GWN76xx Firmware Release Notes

IMPORTANT UPGRADING NOTE

- **Added L2TPv3 tunnel support.**

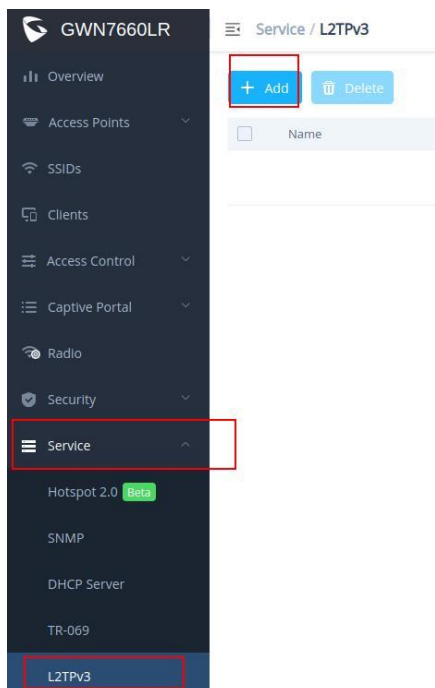
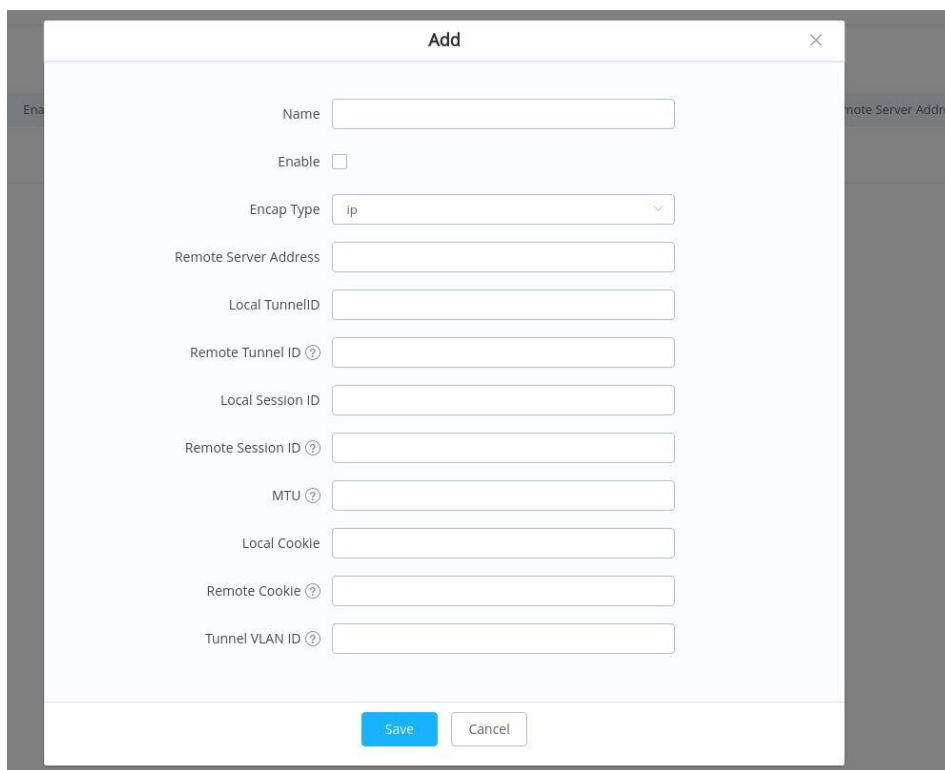
- Added **L2TPv3** tunnel support
- Internal bug fixes

This feature will allow admins to enable and configure L2TPv3 on the device. Please refer to the screenshots and options below.

Note: It is best to set the MTU to match the server to avoid network connectivity issues.

- **Name:** Set the name of the tunnel.
- **Encap Type:** Set the encapsulation type of the tunnel. Valid values for encapsulation are: UDP, IP.
- **Remote Server Address:** Set the IP address of the remote peer.

- **Local Tunnel ID:** Set the tunnel id, which is a 32-bit integer value. This uniquely identifies the tunnel.
- **Remote Tunnel ID:** Set the peer tunnel id, which is a 32-bit integer value assigned to the tunnel by the peer.

- **Local Session ID:** Set the session id, which is a 32-bit integer value. This uniquely identifies the session being created. The value used must match the peer_session_id value being used at the peer.

- **Remote Session ID:** Set the peer session id, which is a 32-bit integer value assigned to the session by the peer. The value used must match the session_id value being used at the peer.

- **Local Cookie:** Set an optional cookie value to be assigned to the session. This is a 4 or 8 byte value, specified as 8 or 16 hex digits, e.g. 014d3636deadbeef. The value must match the peer_cookie value set at the peer. The cookie value is carried in L2TP data packets and is checked for expected value at the peer. Default setting is no cookie used.

- **Remote Cookie:** Set an optional peer cookie value to be assigned to the session. This is a 4 or 8 byte value, specified as 8 or 16 hex digits, e.g. 014d3636deadbeef. The value must match the cookie value

set at the peer. It tells the local system what cookie value to expect to find in received L2TP packets. Default is no cookie used.

- **Tunnel VLAN ID:** The tunnel ID must be set in SSID, and make sure that SSID only has the AP(s) who enabled L2TPv3.
